EDGERTON PLANNING COMMISSION AGENDA
REGULAR SESSION
Edgerton City Hall
May 10, 2016
7:00 PM

To: Edgerton Planning Commission
Fr: Kenneth A. Cook, Community Development Director
Re: Amended FS2016-04 for the Final Site Plan for Logistics Park Kansas City
Phase IV, Second Plat, Lot 1 (IP XXXI)

Requested Action: Amended Final Site Plan – Logistics Park Kansas City – Phase IV, Second Plat, Lot 1 (Inland Port XXXI)

Re: Amended Final Site Plan
Inland Port XXXI - LPKC
31800 W 196th St, Edgerton, KS

Tree List

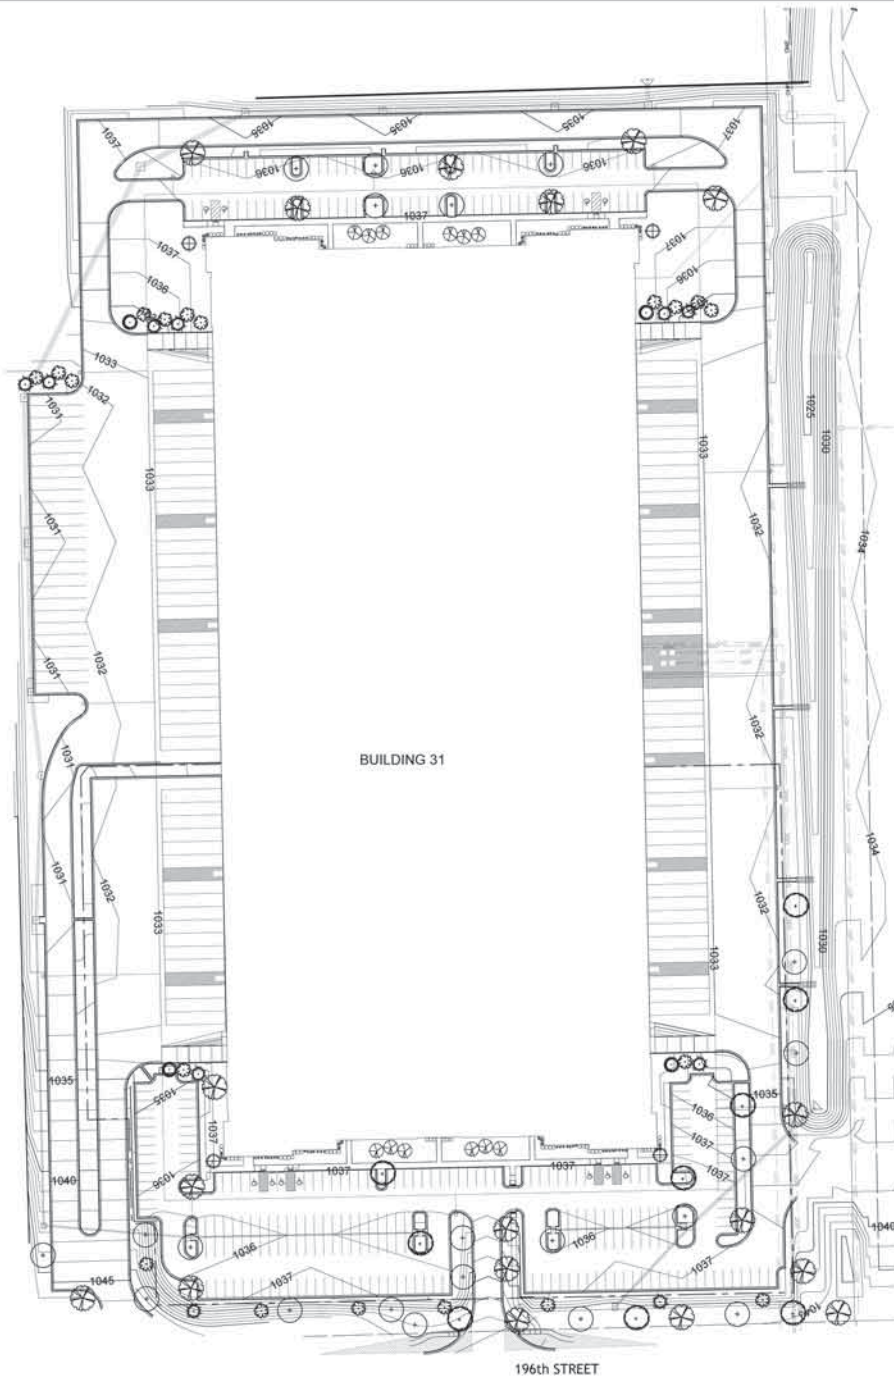
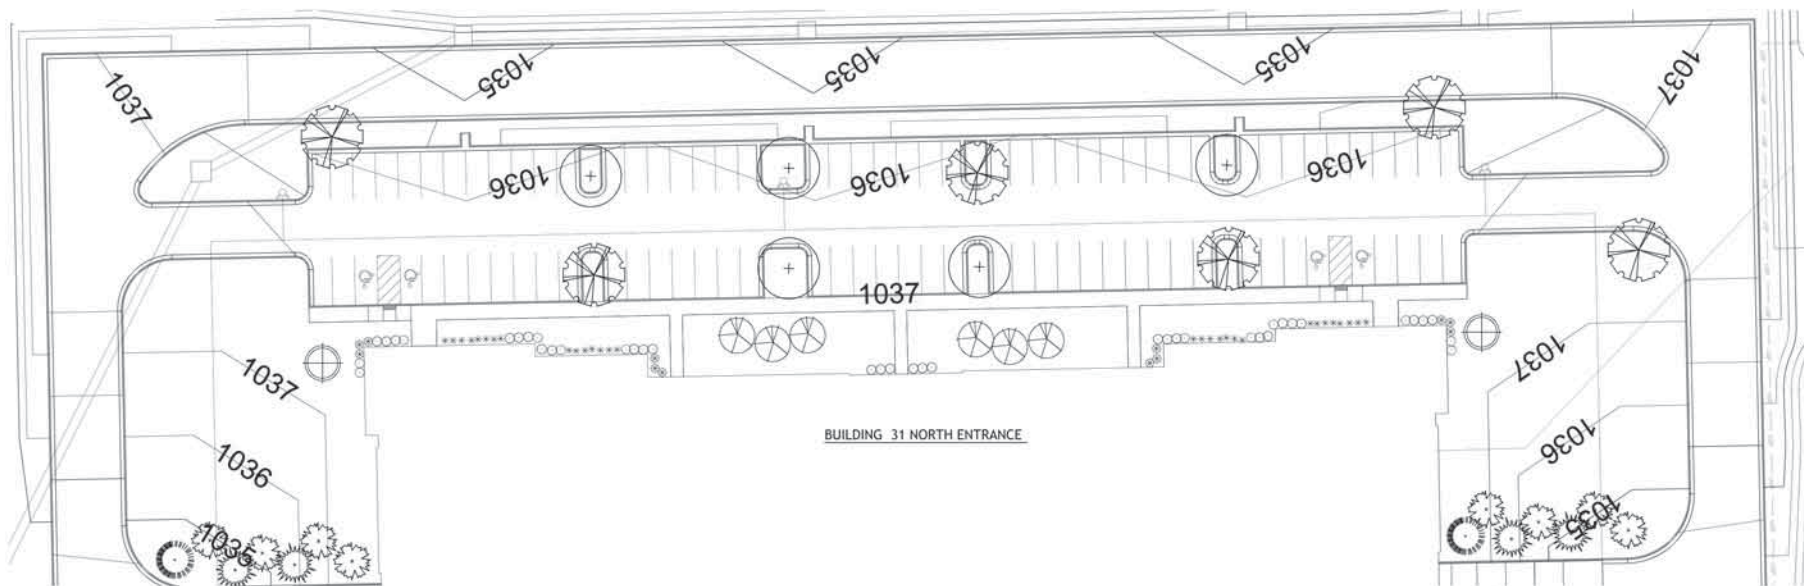
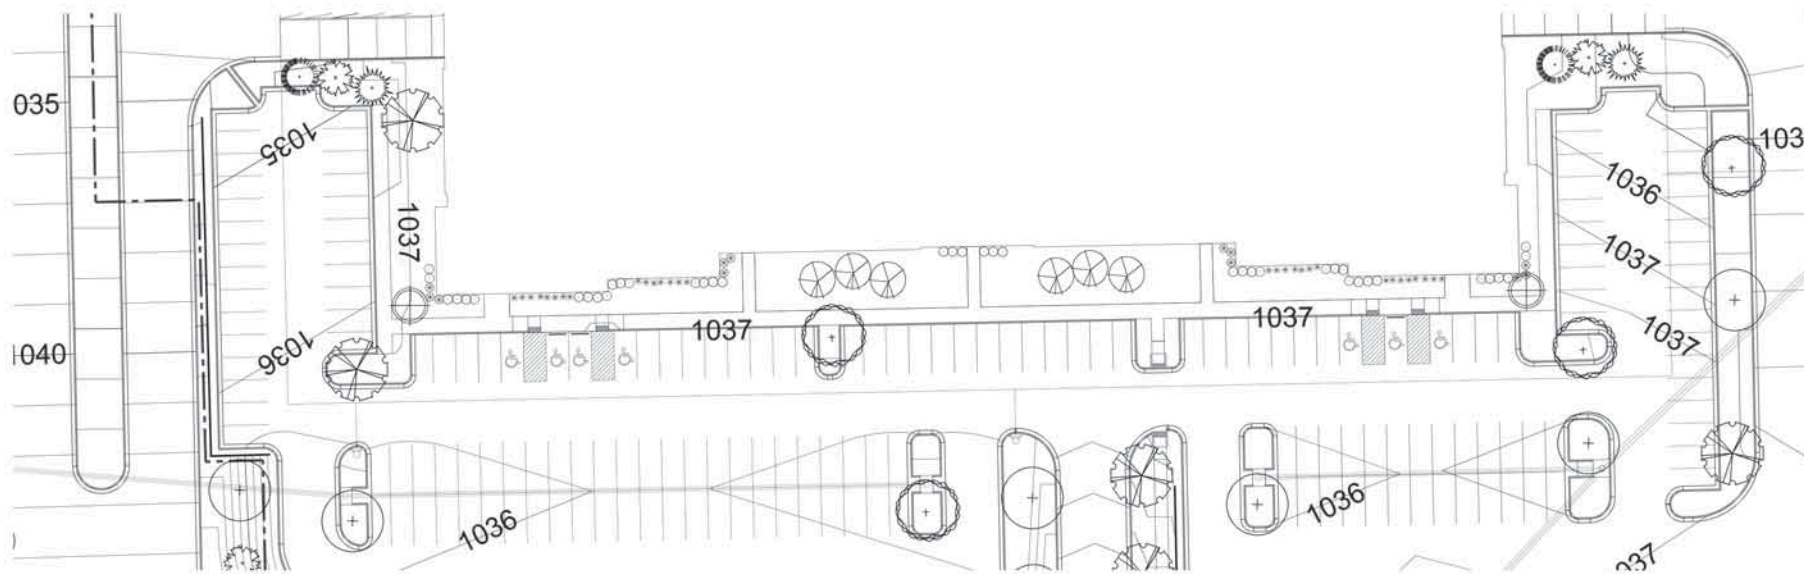
- a) A landscape plan drawn to scale, showing the site, building location, planting and seeding schedules, refuse and outdoor storage screening and boundary screening. All landscape features shall be shown in relation to sidewalks, paths, lawns, parking areas and drives. **Update Final Site Plan.**
 - ~~Trash containers and screening have not been shown.~~
 - ~~The current plan appears to anticipate the division of the structure for two separate tenants. A sidewalk connection should also be made to the Northern portion of the site.~~
- b) A table entitled "Planting Schedule" which lists the common name, size and condition of all planting materials, together with a timetable for planting. ~~No timeline for planting is included.~~ **Update Final Site Plan.**

1. Alternative Landscape Plan. In lieu of the requirements set forth in Section 1.1., Landscaping Standards, an Alternative Landscape Plan (ALP) may be submitted to the Planning Commission for approval. An ALP shall utilize an innovative use of plant materials and design techniques in response to the unique characteristics of a particular site. At a minimum, an ALP shall contain equivalent landscaping as is required by these regulations. *In general, the applicant has prepared a plan that is designed to be similar to the Landscaping that has been provided in other projects. Staff suggests that additional landscaping be provided at the entrances into the site as the normal standard would require shrubs spaced at intervals along the entire frontage of the property and back to the front of the building alongside property lines. The updated plans also provide additional information in to the type of fencing that is being proposed for the site and the applicant has also placed additional landscape material between the fence and the street due to the small distance and to break up the look of the fence.*

1 SOUTH ELEVATION
Scale: 1/8"=1'-0"
FDP APPROVED (03/22/16)

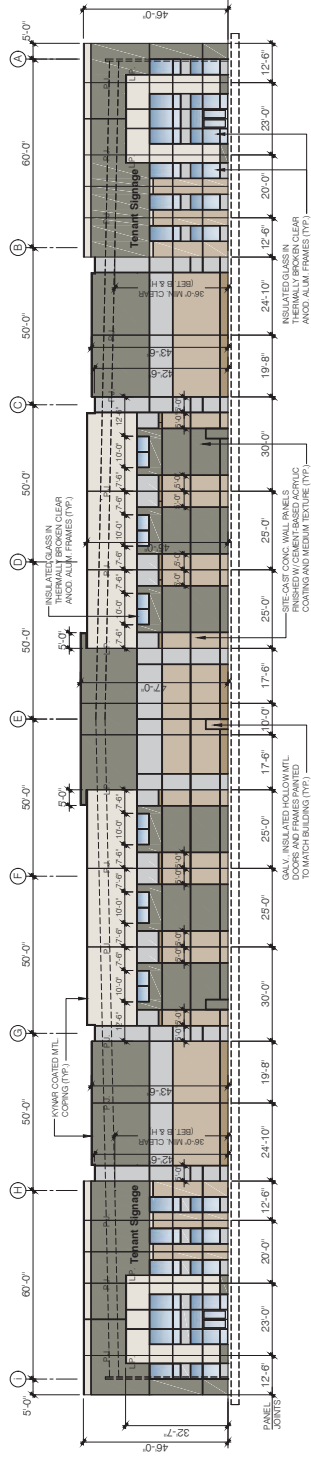
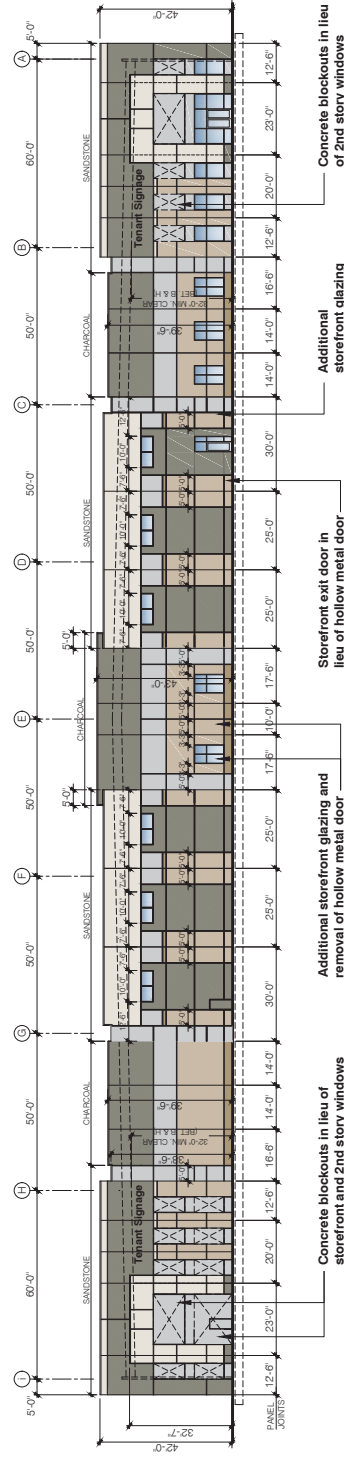
articulation requirement. *The middle of the south wall measures approximately 205 feet, which appears to be the slightly less than the dimension that has been used on previous plans. With the height of the wall ranging between 42'-6" and 47'-6" and 43 feet the maximum length of this wall without additional horizontal articulation should be 188 172 feet. The required horizontal off-set along this wall is between 3.85 and 4.3 feet. The off-sets that are provided are 5 and 10 feet, respectively. This means that the proposed building does not meet the horizontal articulation requirement due to the length of the middle section of this wall. The change in the proposed height of the structure does create the issue that the building is technically further out of compliance than was originally requested. However, this is only a very minimal change. Additional articulation could be provided in this area or the articulation provided at the East and West portions of this wall could be extended to shorten this distance. This is the same issue that has been discussed as part of previous approvals. The Planning Board has allowed exceptions to this requirement in the past based upon reviewing the building elevation and design and determining that the applicant is using some of the additional design elements listed in Section 5.2J.2 to give the appearance of breaking up the length of the building and to allow for a common design to be used between the buildings that are being proposed. **The south wall does not meet this requirement. The Planning Commission may decide to approve exceptions to all or portions of this plan based upon the façade elevations that have been provided and to allow for this building to maintain a consistent appearance with the adjacent development.***

1. Remove southwest corner storefront and windows.
2. Add additional doors and windows in the eastern half of the south elevation.
3. Lowering the building from 36-ft clear (at first column line) to 32-ft clear height.
4. Added entrance for passenger cars from W 196th St. (option for tenant)
5. Sidewalk access for north tenant to W 196th St.
6. Fence details

Clear height revised from 36'-0" to 32'-0" —
